Application No.: 10/608,671

**Amendments to the Drawings:**

## **REMARKS**

Fig. 1b

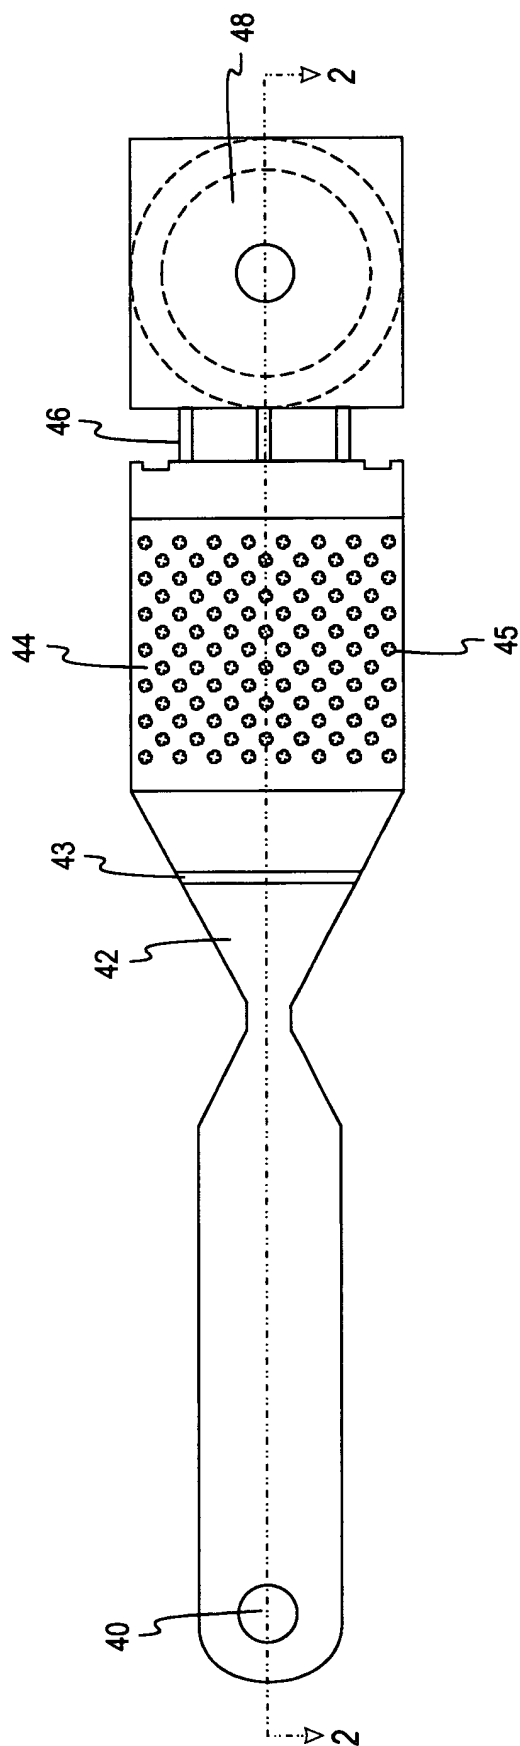
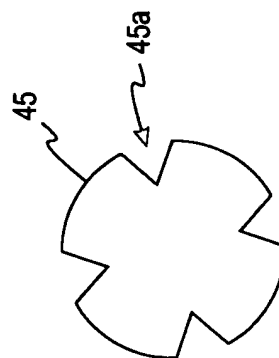
Please replace Fig. 1b-c with the enclosed replacement sheet.

Corrected drawings are attached in compliance with 37 C.F.R. 1.121(d). Corresponding marked-up sheets, showing the revisions in red are included. No amendments to the specification are believed to be needed. Section marks have been added to Fig. 1b and Fig. 2 has been revised accordingly. It is believed that the unidirectional capillary passageway 42, extending from inlet 40 to the inlet chamber 44 is clearly shown in Fig. 1b and Fig. 2. Fig. 3a-c merely illustrate schematically alternatives to the structure of Fig. 2, as discussed on page 8 of the specification.
